ISSUE: Certificate of Appropriateness for alterations

APPLICANT: Landini Restaurant, Inc. Noe Landini

LOCATION: Old and Historic Alexandria District
115 King Street

BAR APPLICATION EXTERIOR DUCTWORK V2
May 10, 2023

SHEET TITLE: ENLARGED REAR EXTERIOR PLAN REV

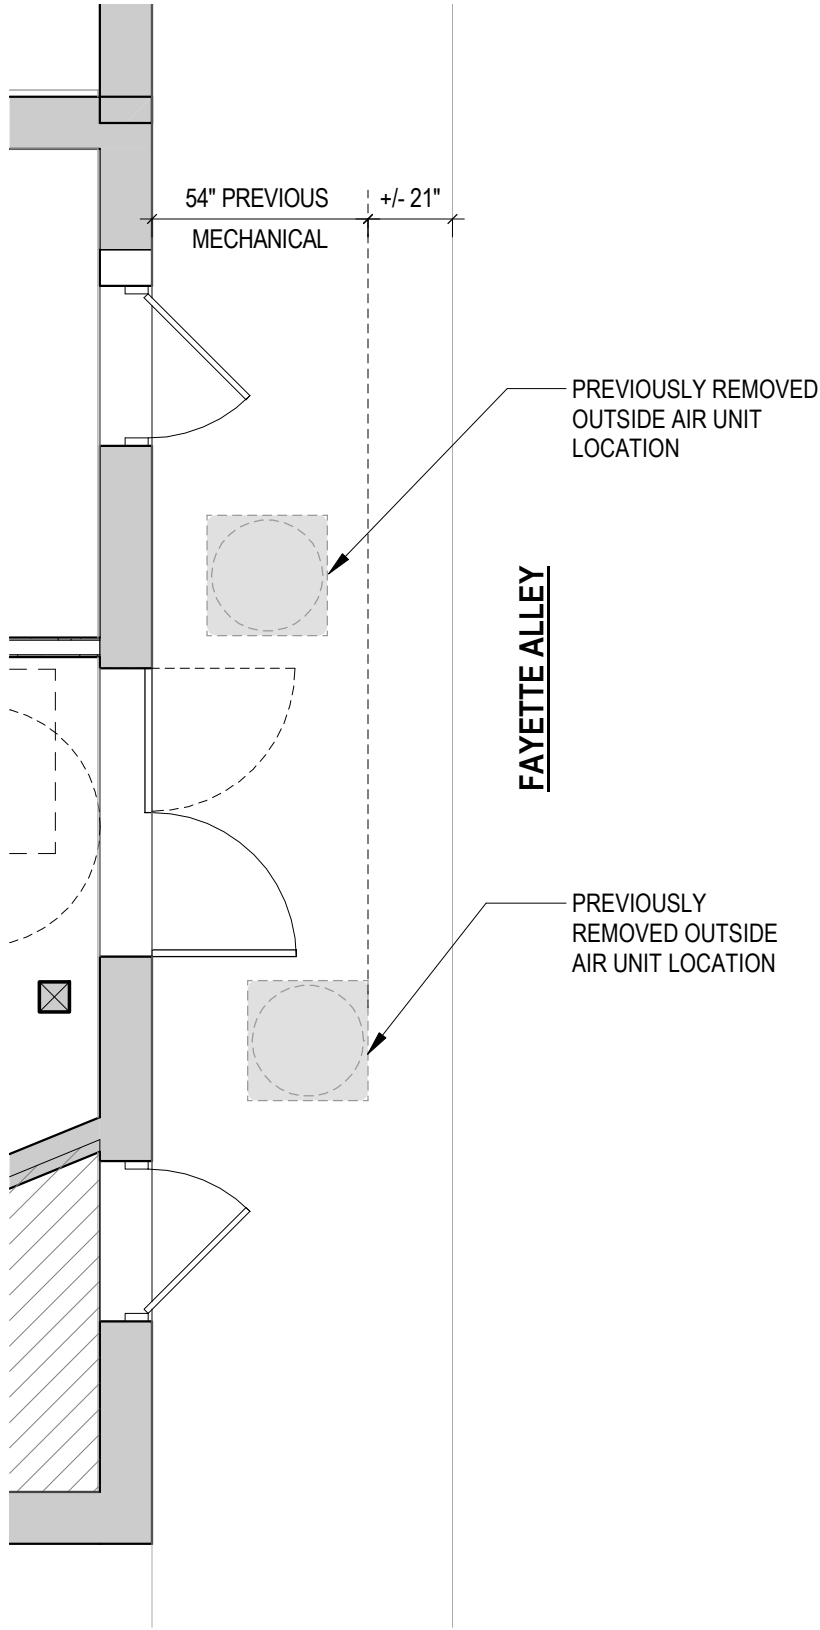
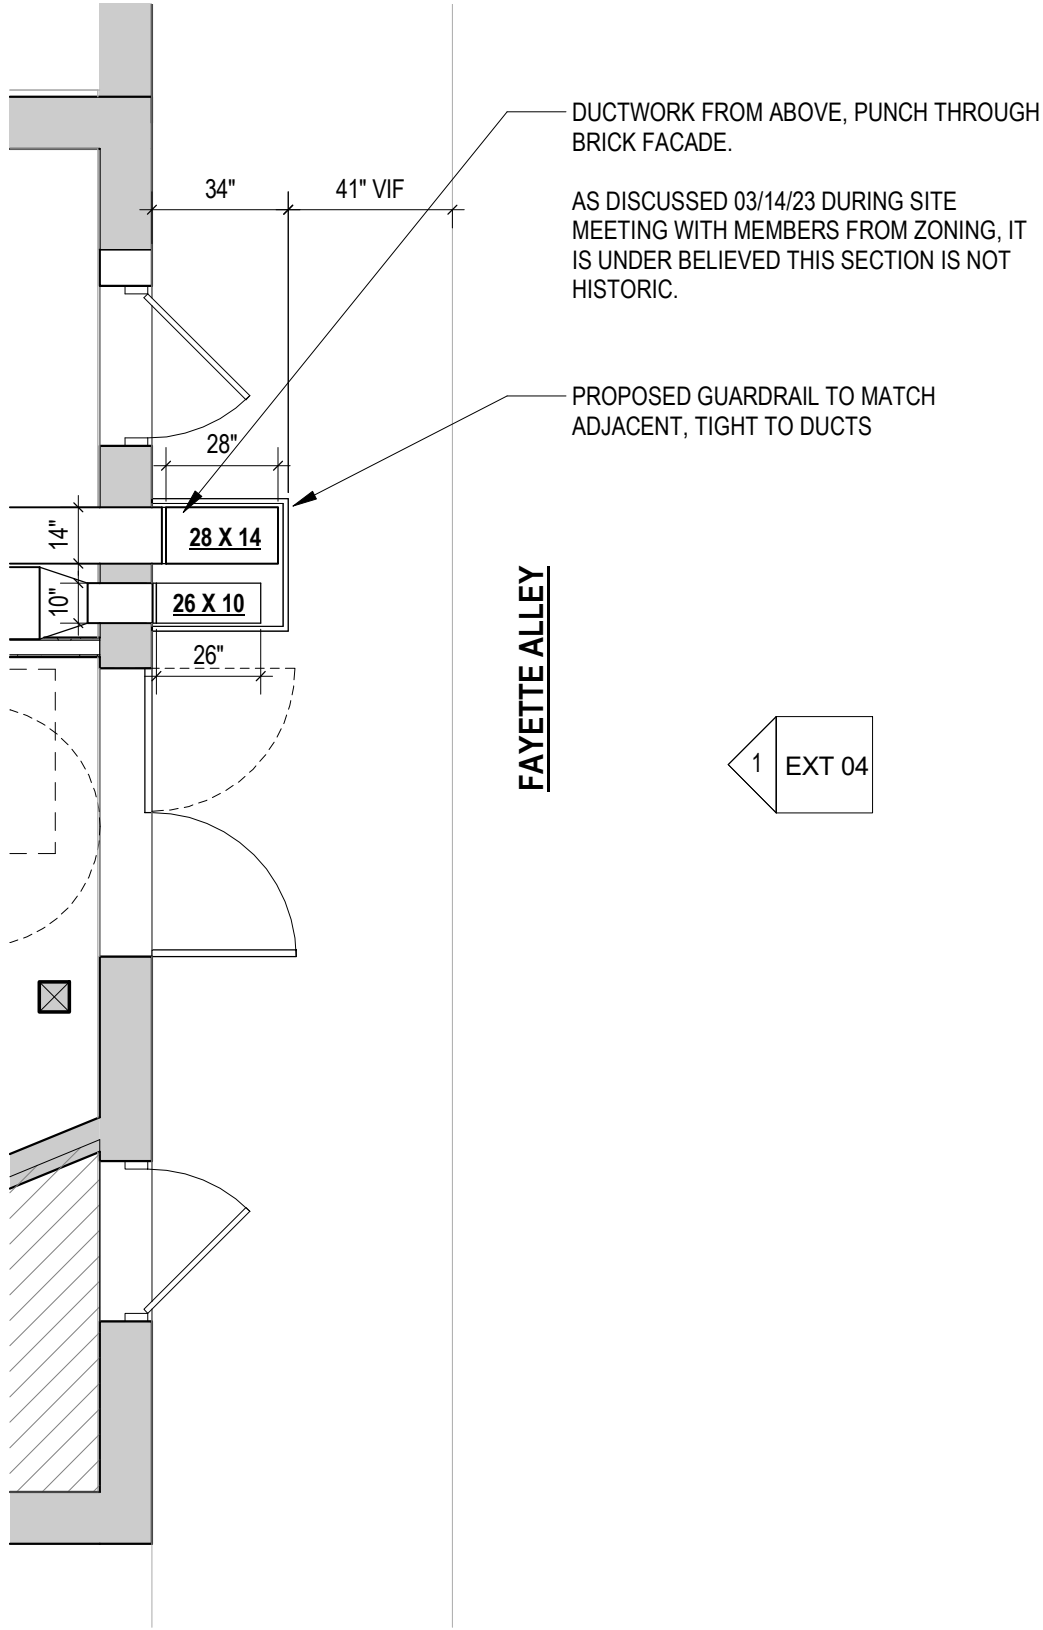
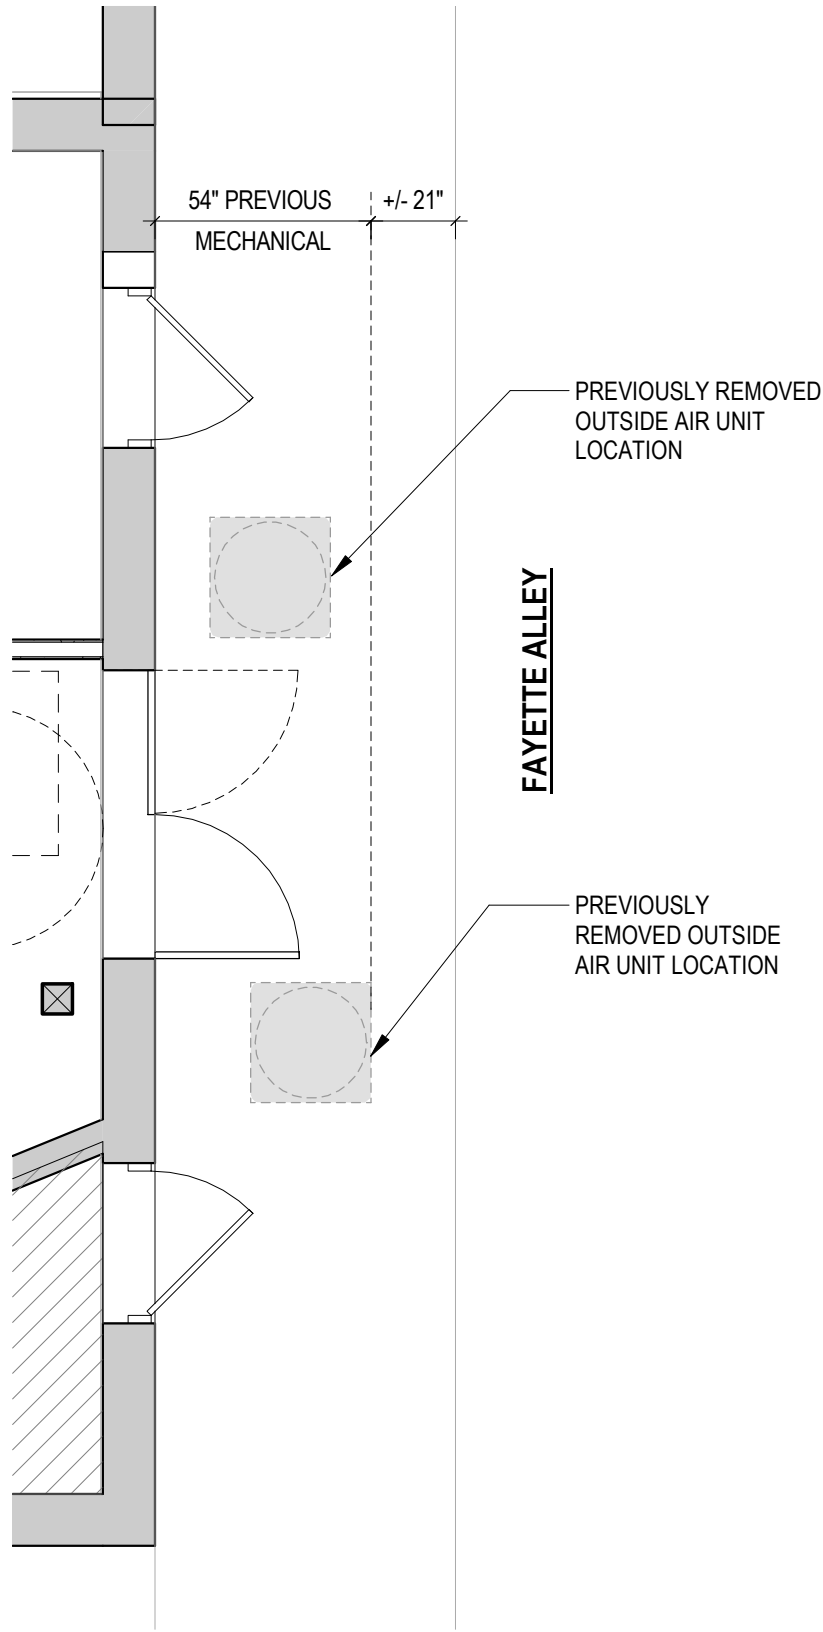
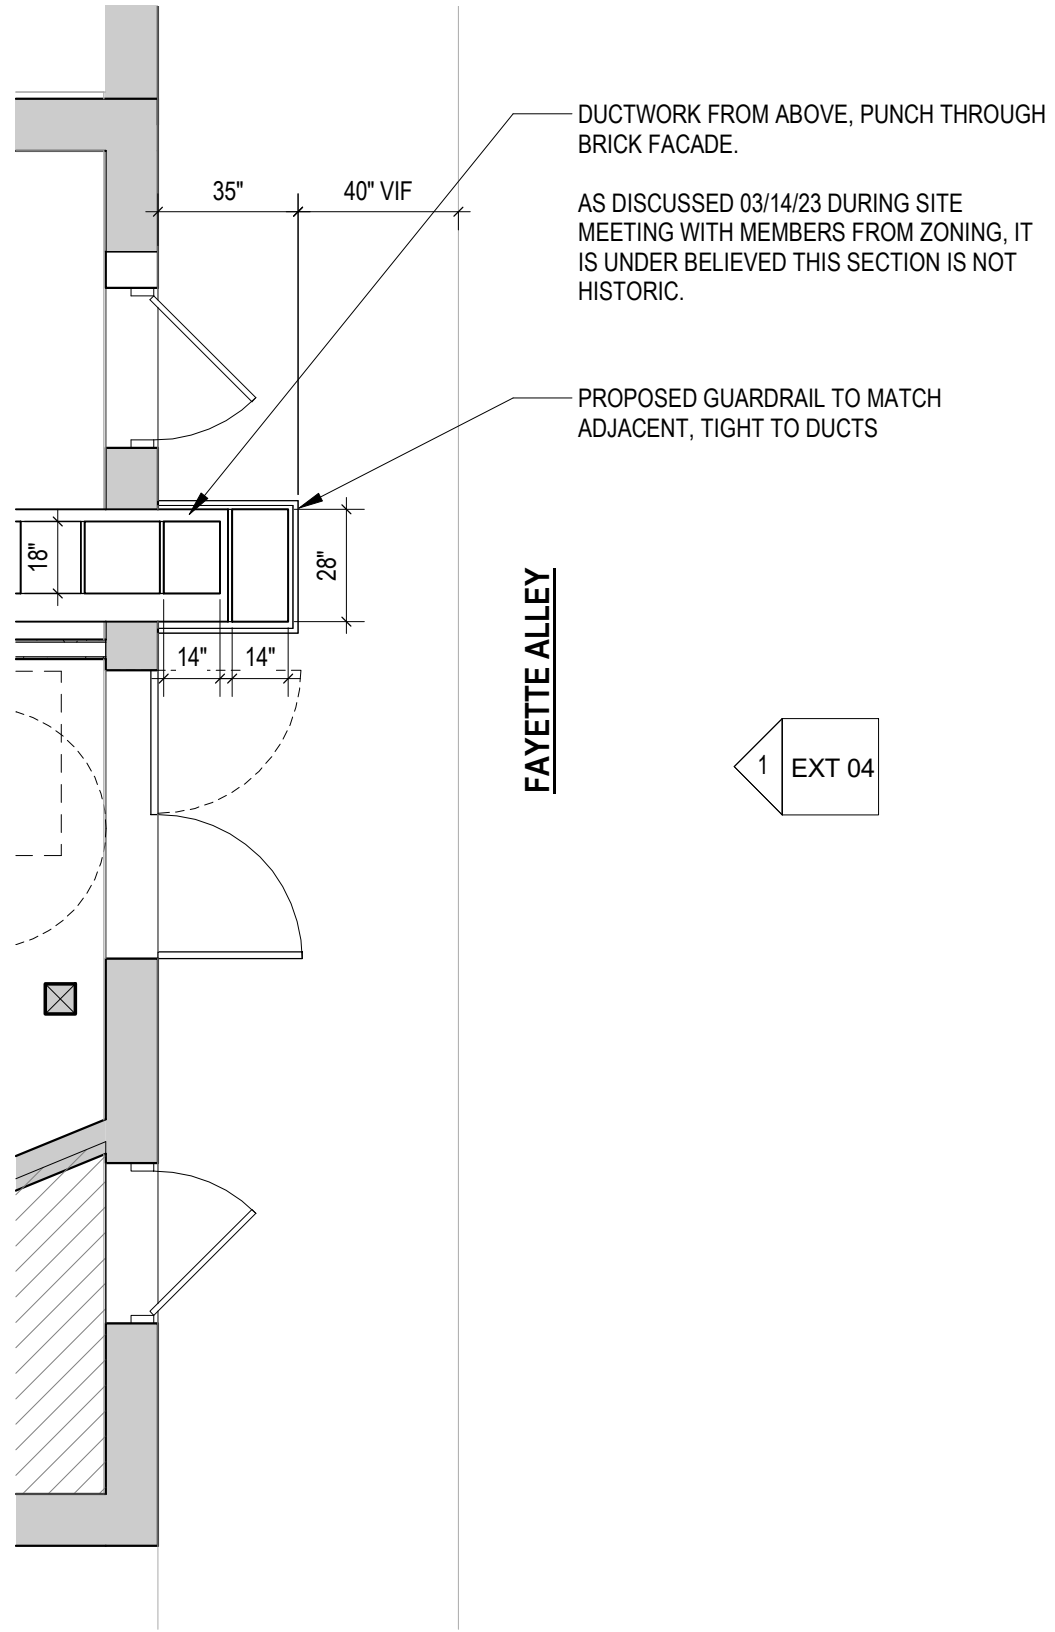
REVISED PER 5/4
HEARING COMMENTS
